April 11, 2019

To: Ridgeland WRF Expansion Plan Holders

Re: Addendum #1
Ridgeland WRF Expansion

Splitter Box Section

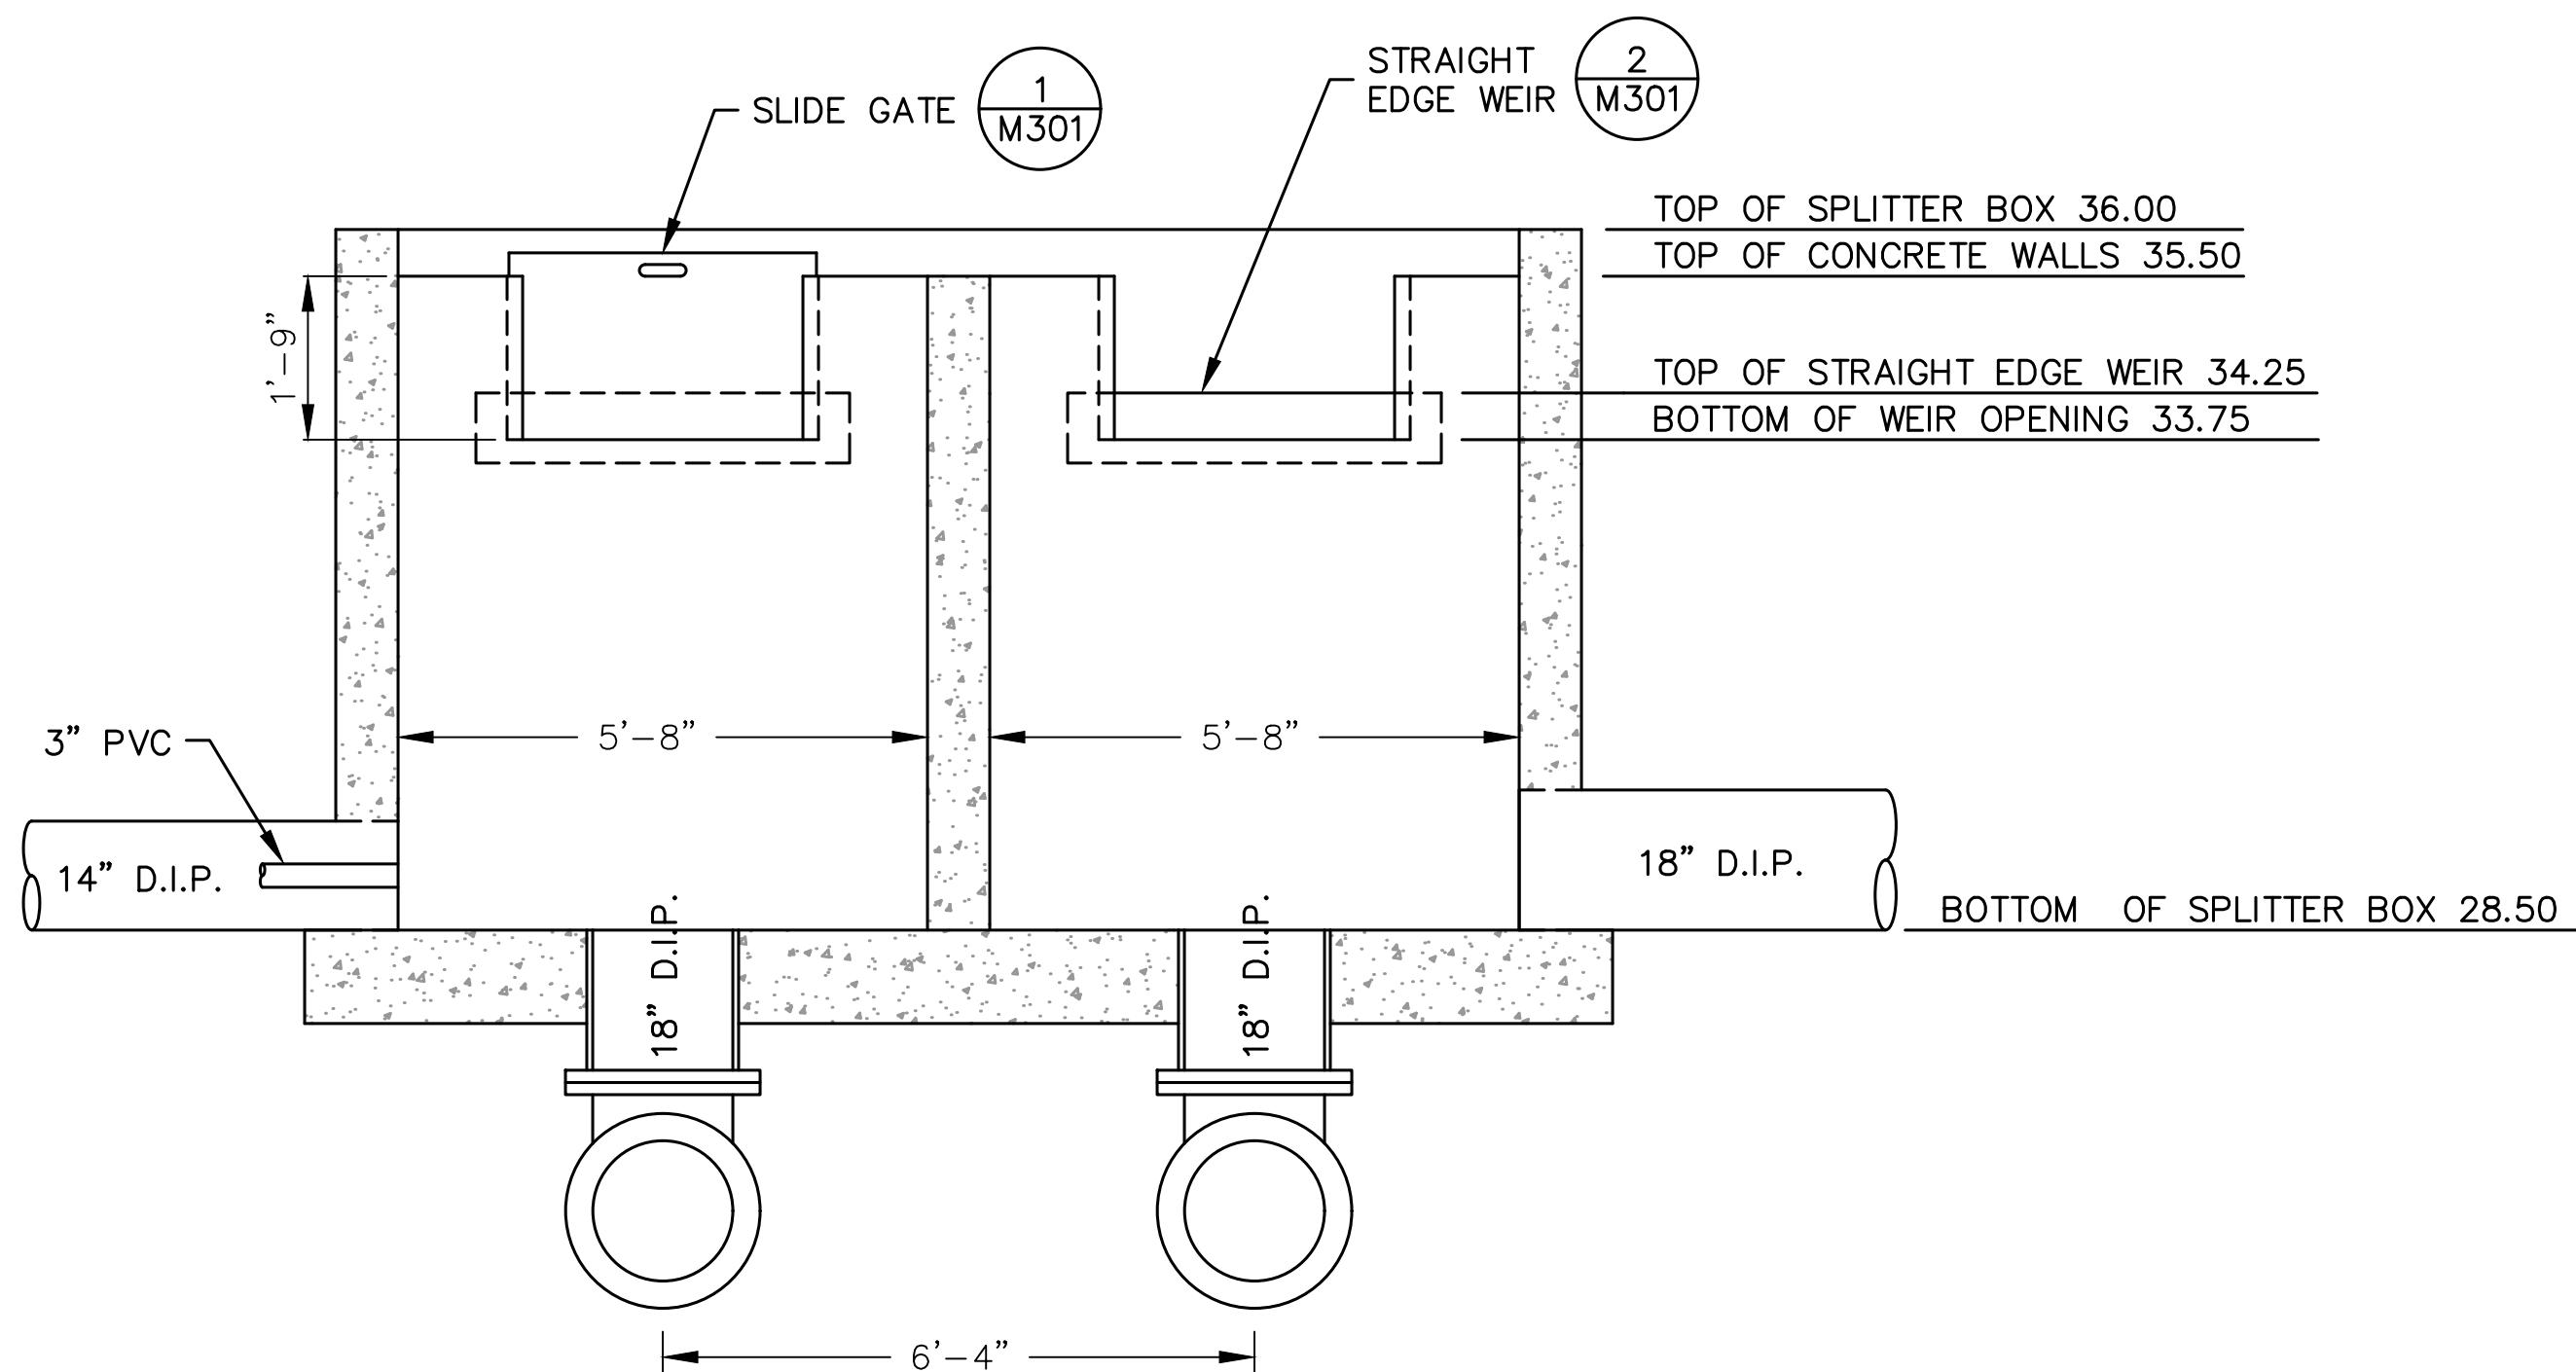
1.2 PIPE FROM HEADWORKS RELOCATED

CLIENT: **Town of Ridgeland**
PROJECT: **Jimmy Mixson WRF Expansion**
SHEET TITLE: **ICEAS Tank Plan**

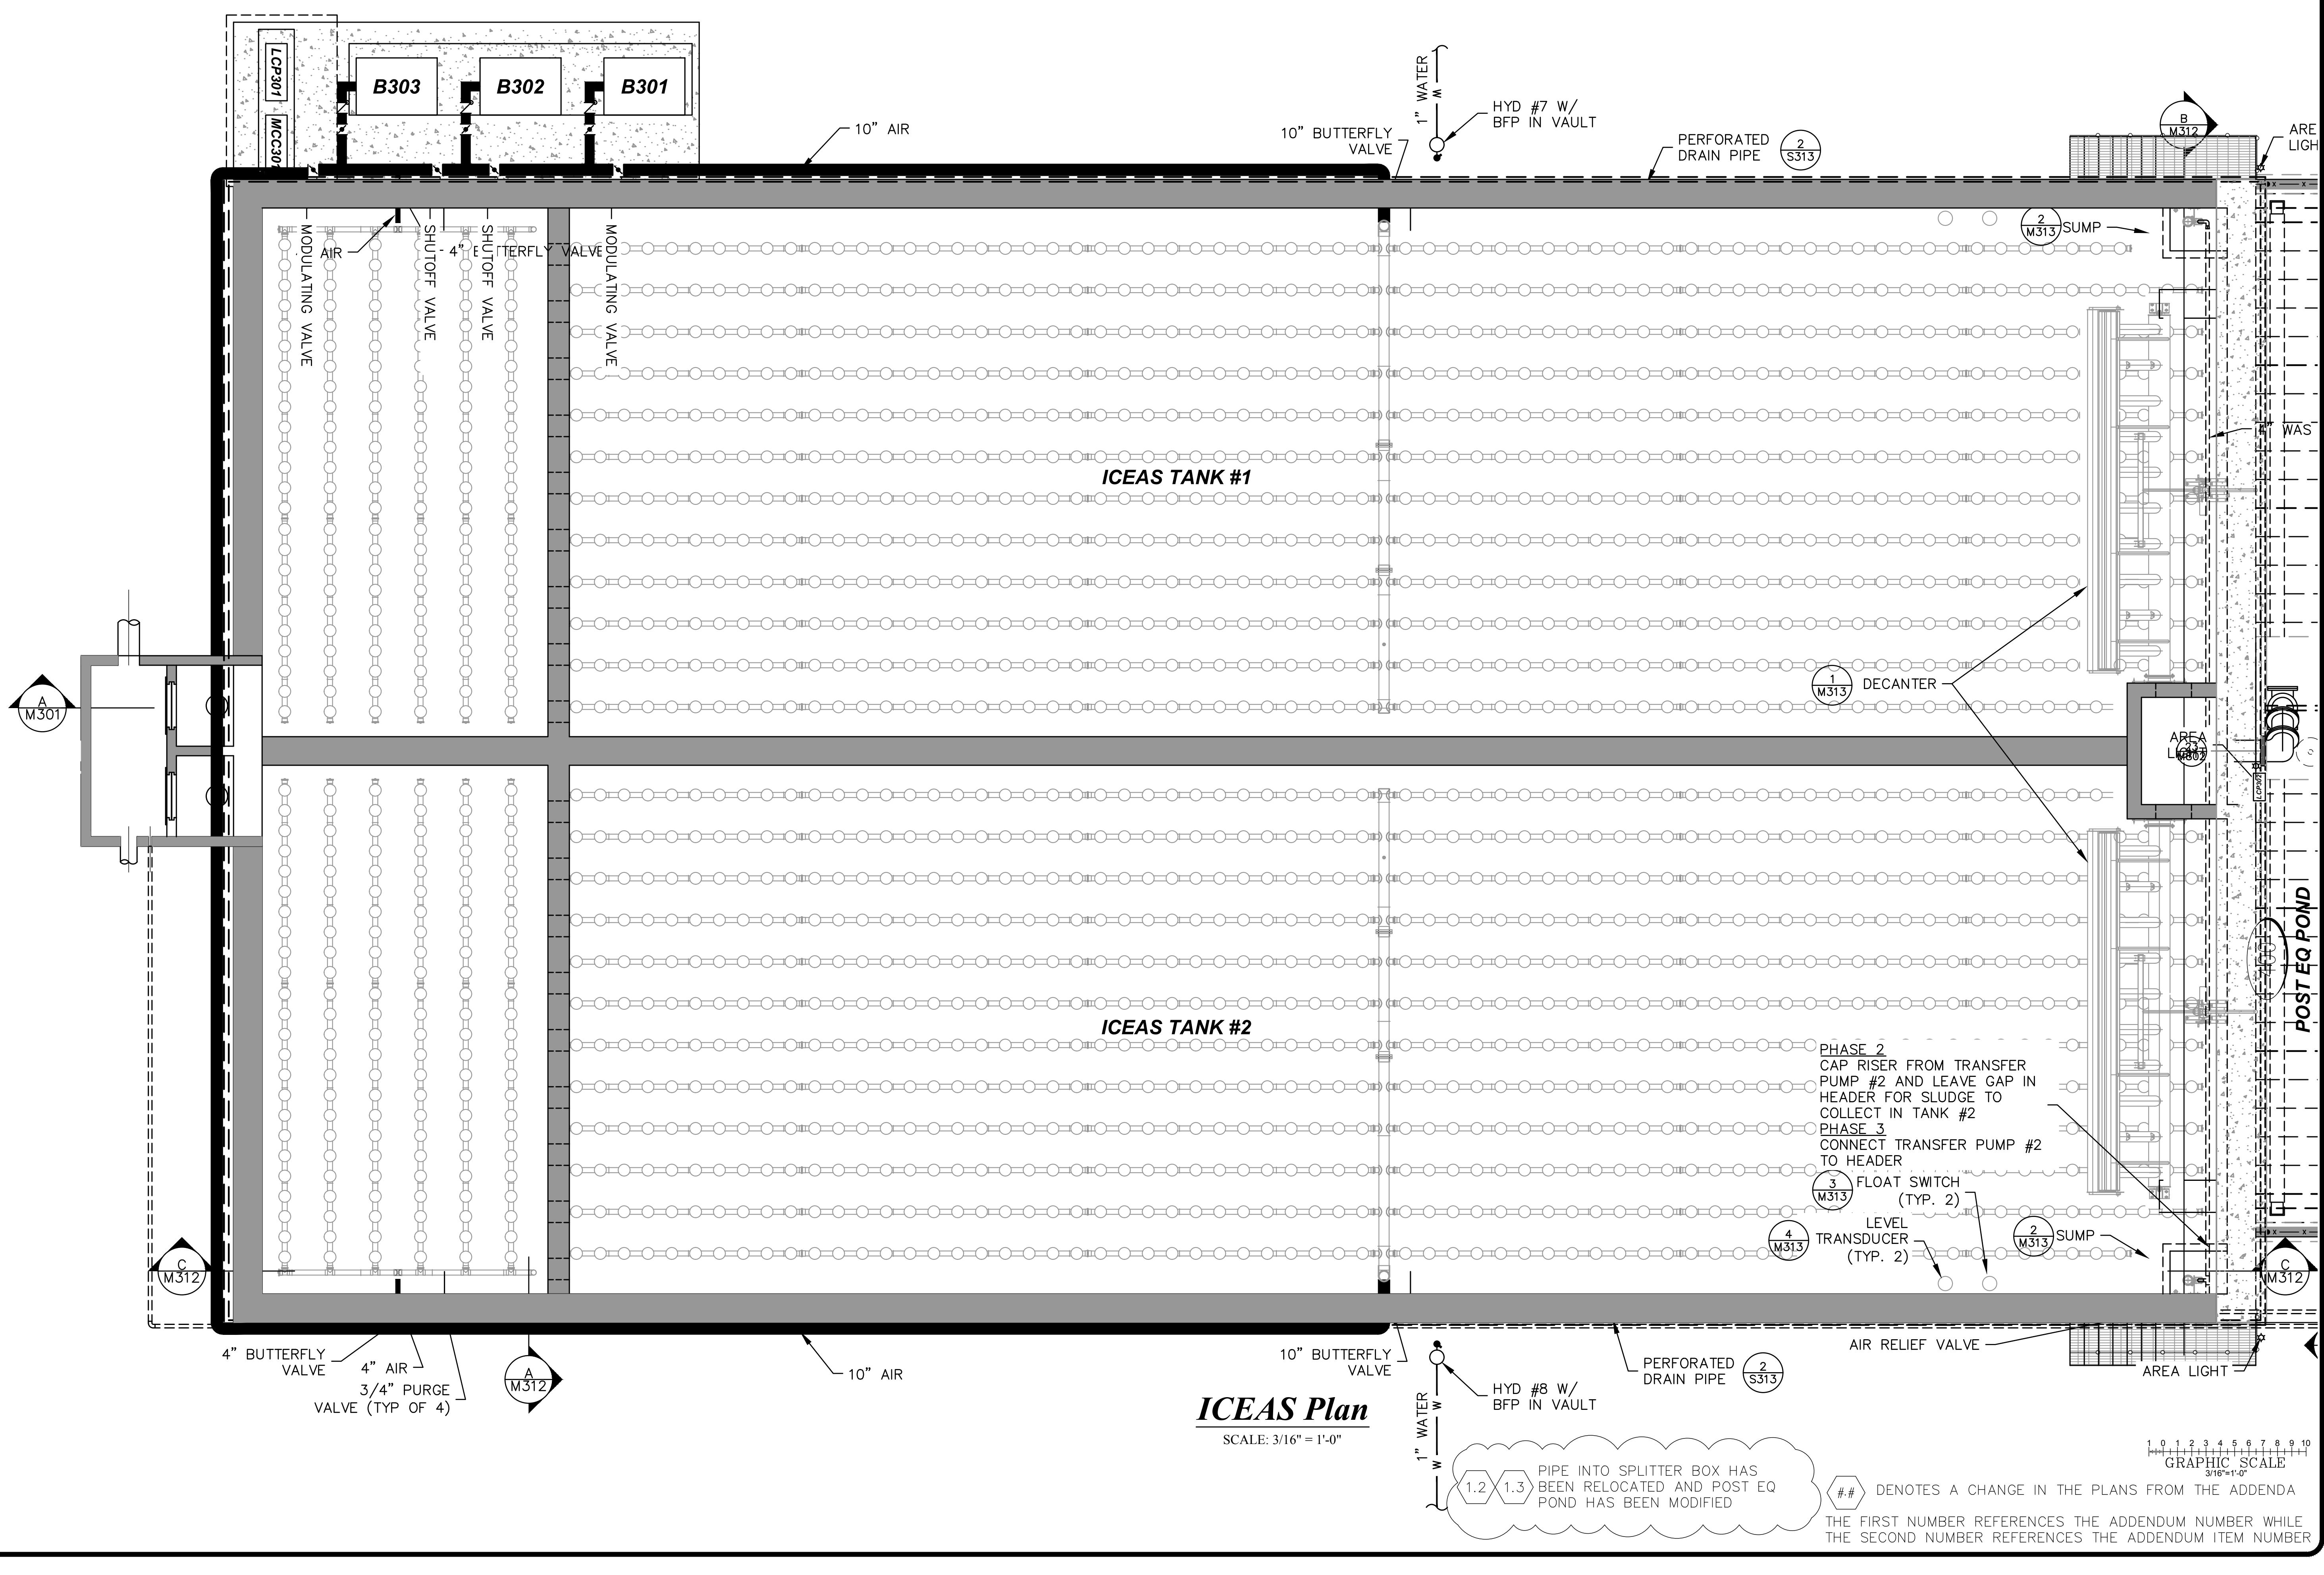
1.14	ICEAS details - M313	<p>1. M313 has been reissued with better quality images.</p>
1.15	Section 00 41 00 Bid Form	<p>1. Eliminate adders #3 & #4 for concrete lining of post-EQ and digester.</p> <p>2. An alternate #3 is added for the digester and sludge processing area.</p> <p>3. Eliminated separate lines for taxes. The project is tax exempt for items related to the construction of process related equipment.</p> <p>4. A new Article 5 – Bid Form is provided.</p>

{ 1.14 POOR QUALITY IMAGES REPLACED WITH BETTER QUALITY ONES }

SHEET NO.
M402

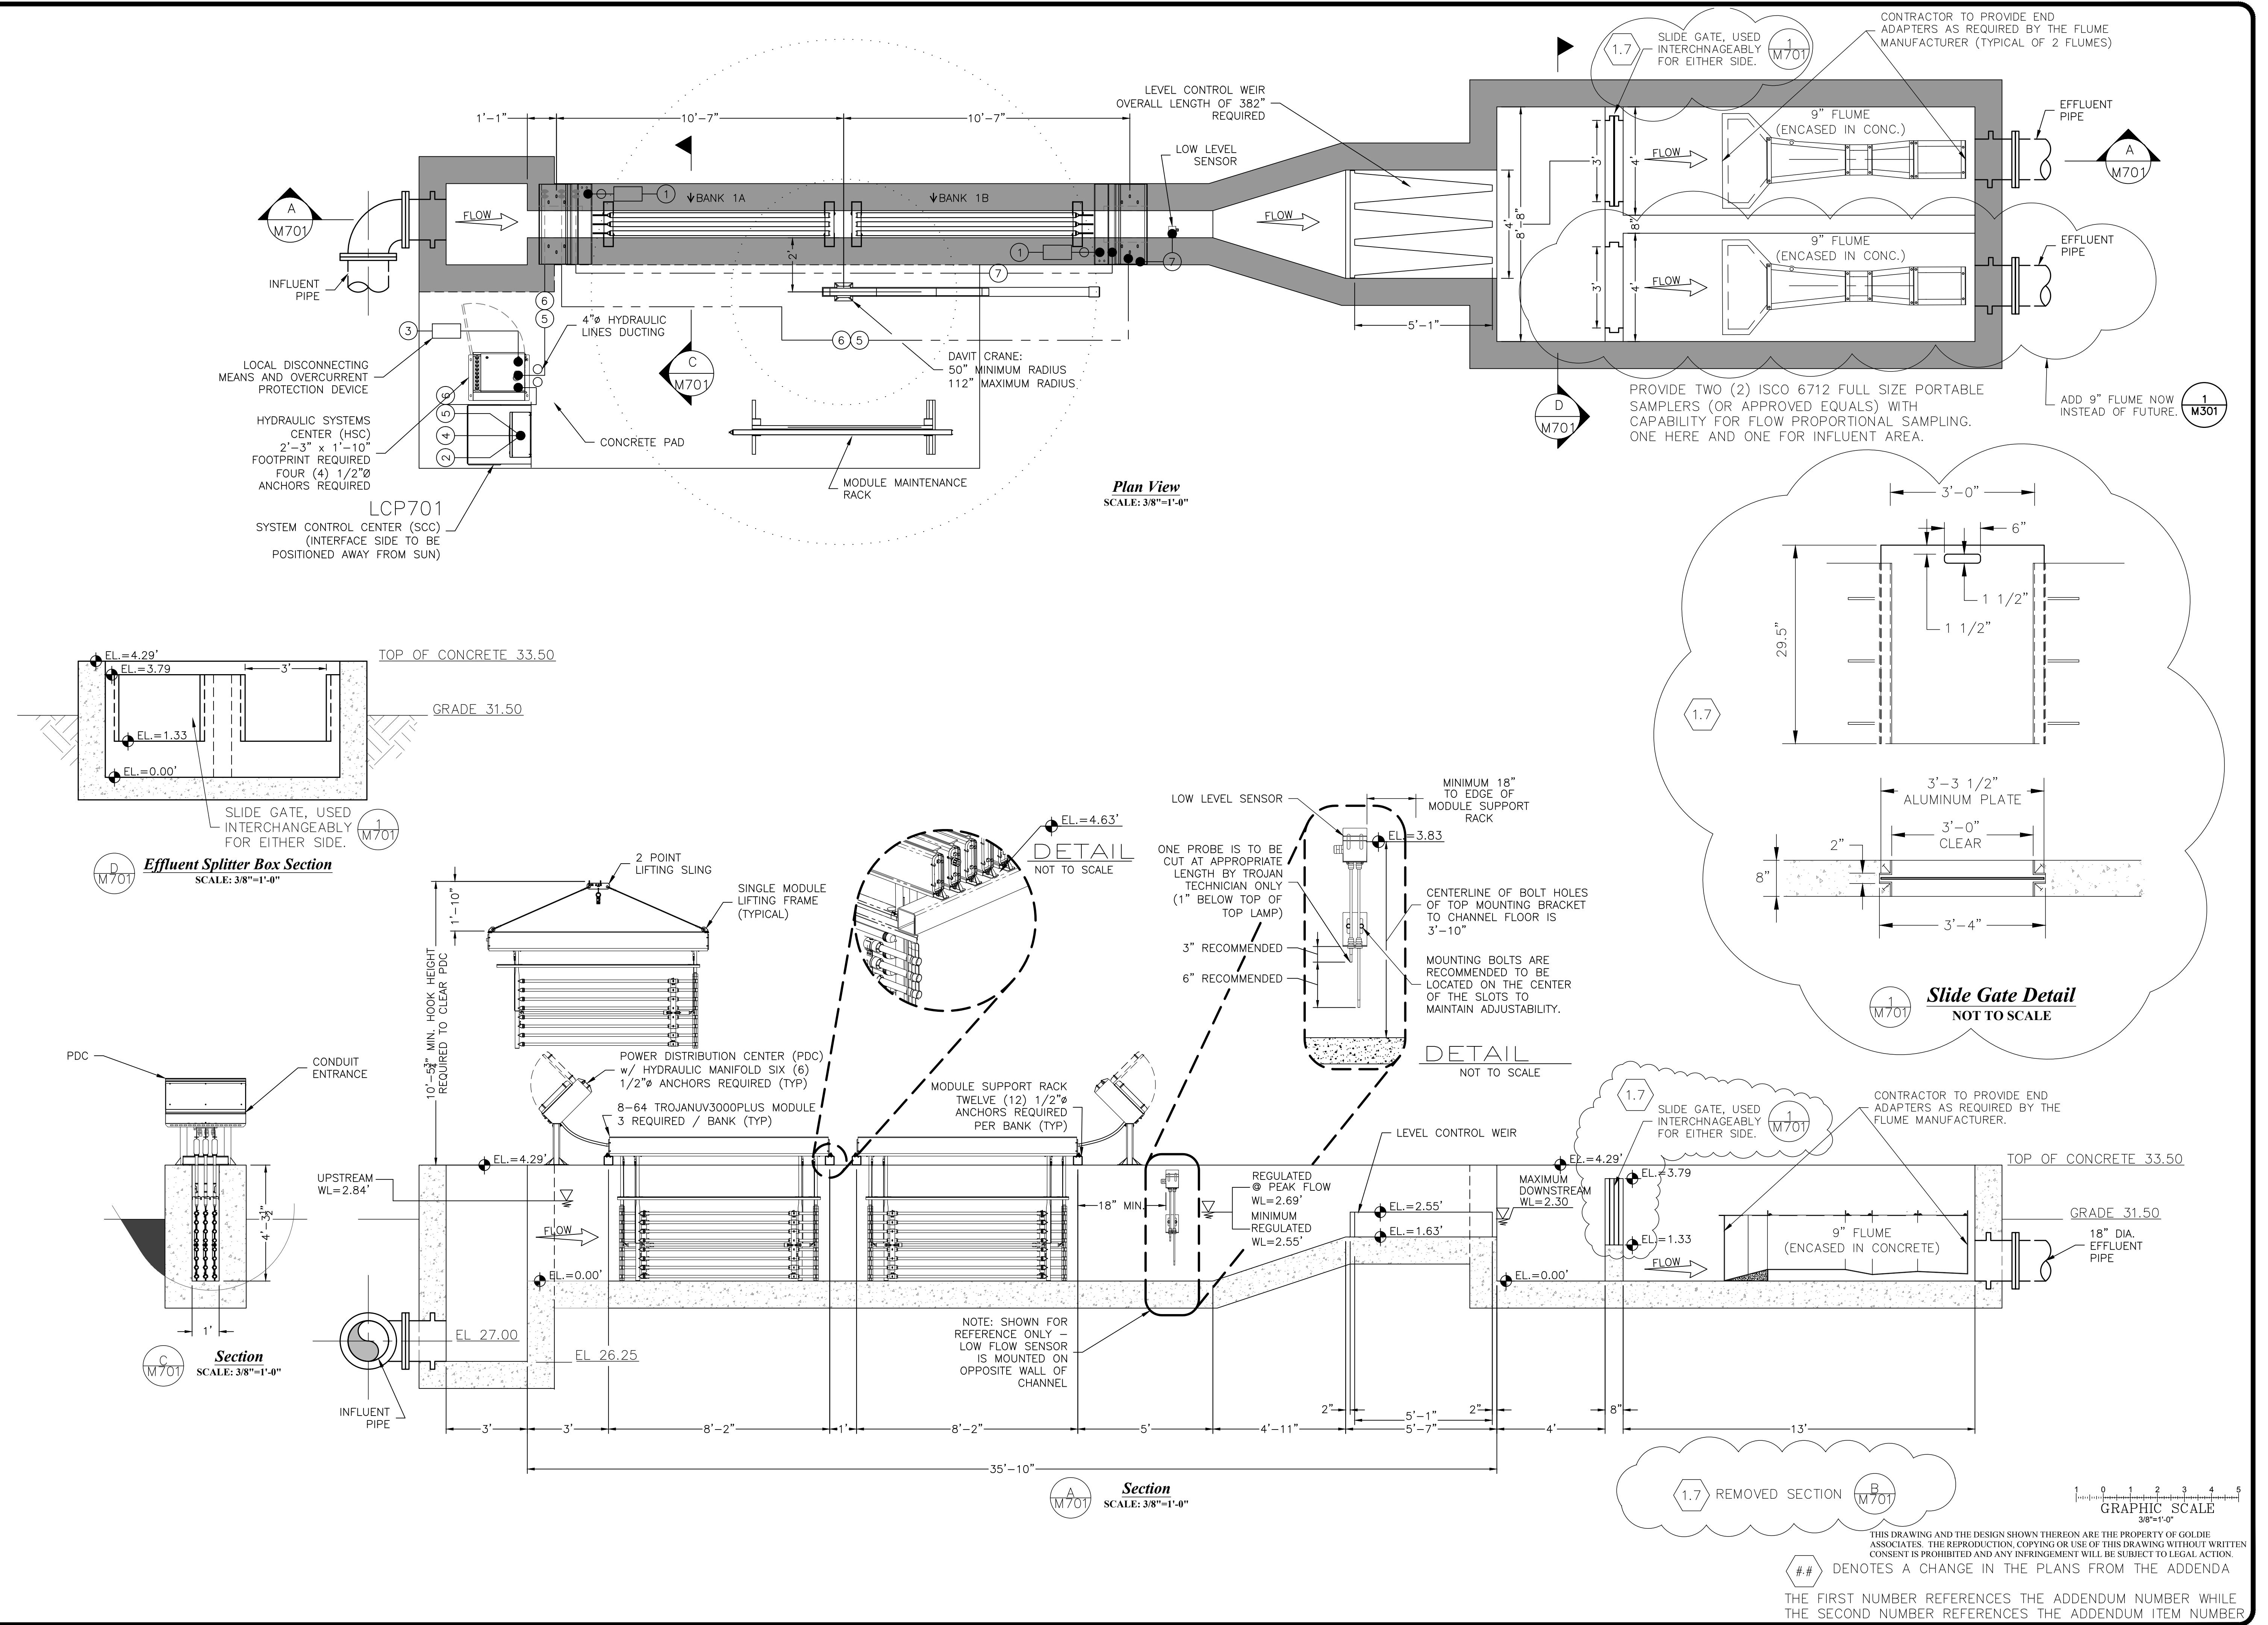
Addendum Reference #	Reference	Question / comment
1.3	Post-EQ Pond - ESC002, M400s & S400s	<ol style="list-style-type: none"> The shape of the EQ pond has been modified. The headwall has been eliminated. Use a pipe boot for the effluent pipe.

1.4	Post-EQ Pond - M400s, S400s, E013, CS001 & CS012	<ol style="list-style-type: none"> The post-EQ blowers and diffusers are being replaced with a floating aerator.
